<b>DOCKETED</b>	
<b>Docket Number:</b>	23-OPT-01
<b>Project Title:</b>	Fountain Wind Project
<b>TN #:</b>	248330-2
<b>Document Title:</b>	Project Refinement Memo September 2021
<b>Description:</b>	N/A
<b>Filer:</b>	Caitlin Barns
<b>Organization:</b>	Stantec Consulting Services, Inc.
<b>Submitter Role:</b>	Applicant Consultant
<b>Submission Date:</b>	1/5/2023 10:09:40 AM
<b>Docketed Date:</b>	1/5/2023

To:	Shasta County Planning Department and Board of Supervisors	From:	Stantec Environmental Services
File:	Fountain Wind Project	Date:	September 24, 2021

**Reference: Analyses of Refinements to the Proposed Project Design Since Circulation of the Final Environmental Impact Report**

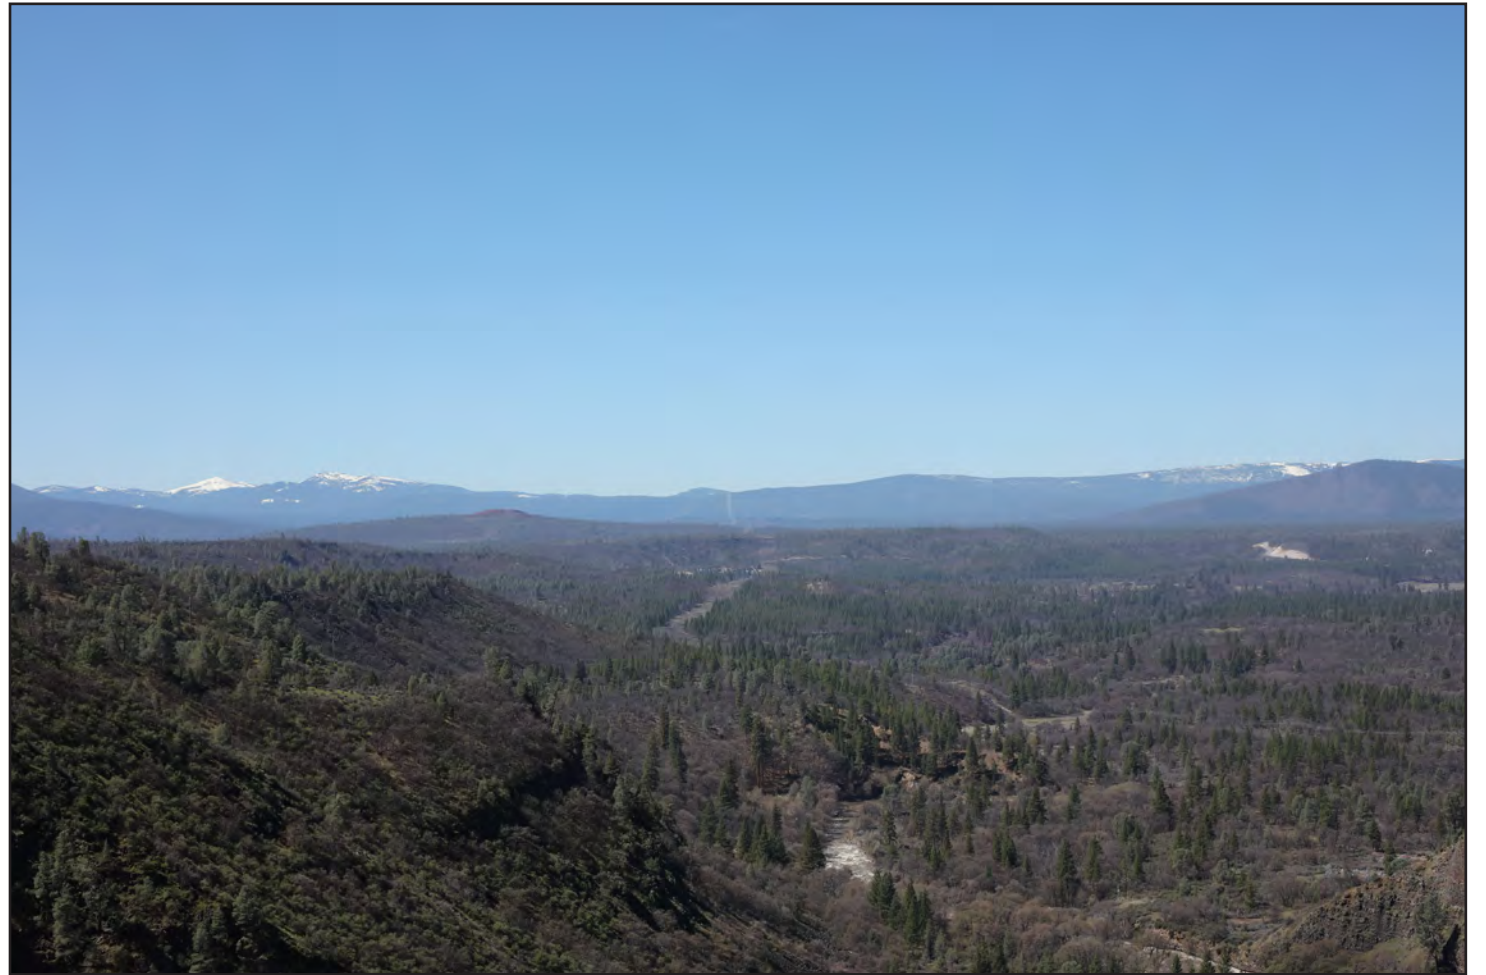
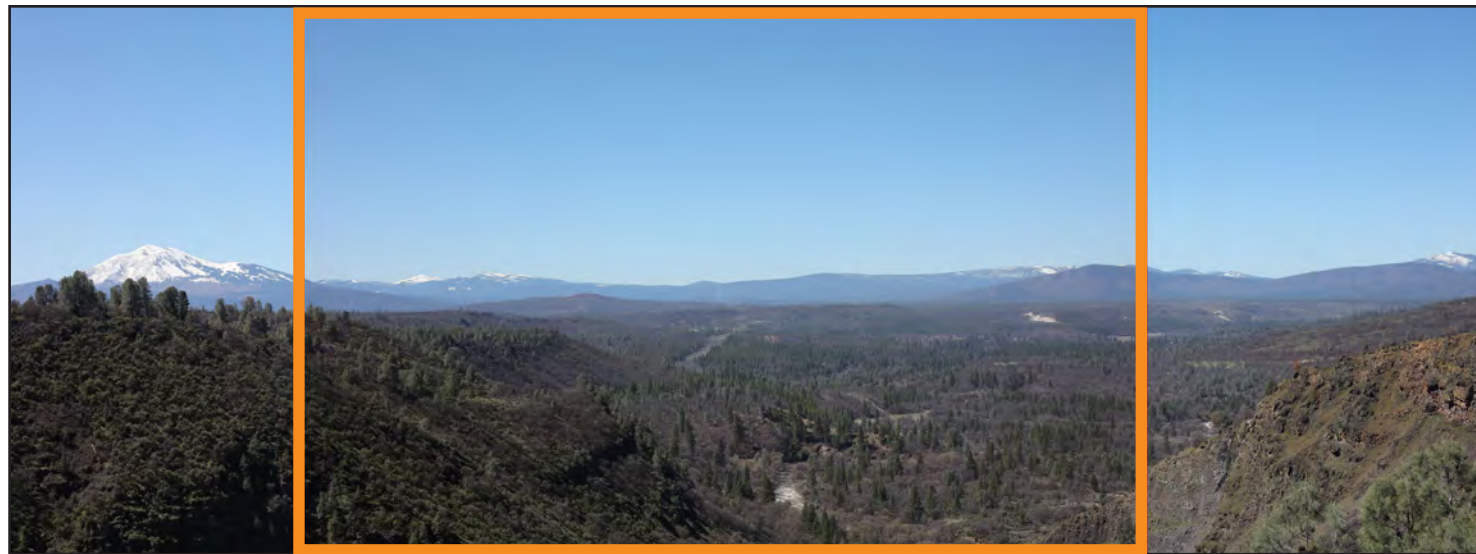
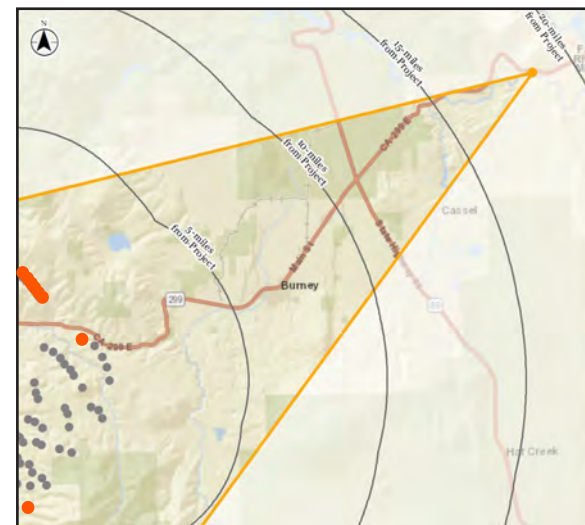
- **KOP 6: SR 299 Pit River Overlook** – Twenty-three turbines would be visible in this broad view from 19 miles away (compared with 36 under the 72-turbine layout), appearing below, along, and beyond the same ridgeline along which Hatchet Ridge turbines currently appear (Figure 6-6).

A: View from KOP 6 with 72-turbine layout simulated as evaluated in the FEIR. The 72-turbine layout would be visible just under 19 miles away, alongside the Hatchet Ridge Wind Project.

B: With the 48-turbine layout, fewer turbines would be discernable along, beneath, and beyond the distant ridgeline. The Project would remain broadly visible in the distance.

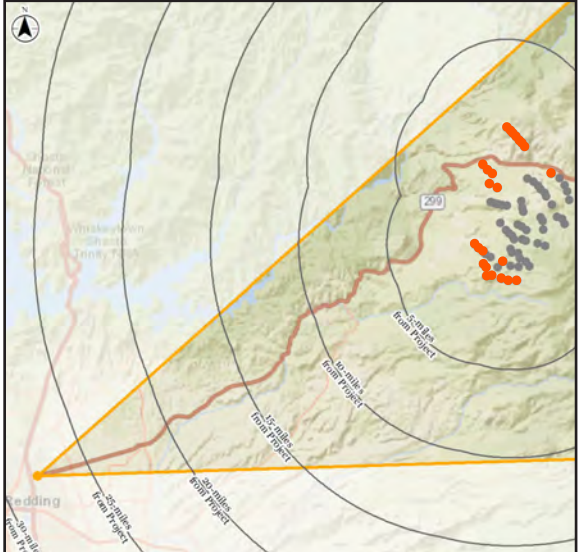
- **KOP 7: Redding** – From just under 28 miles away, project turbines under the 48-turbine layout would appear in the same general portion of this view, though at a lower density than with the 72-turbine layout (Figure 6-7).

A: View from KOP 7 with 72-turbine layout simulated as evaluated in the FEIR. Project turbines would be visible just under 28 miles away.

B: With the 48-turbine layout, a reduced number of turbines would be visible within the same general area from this distance.
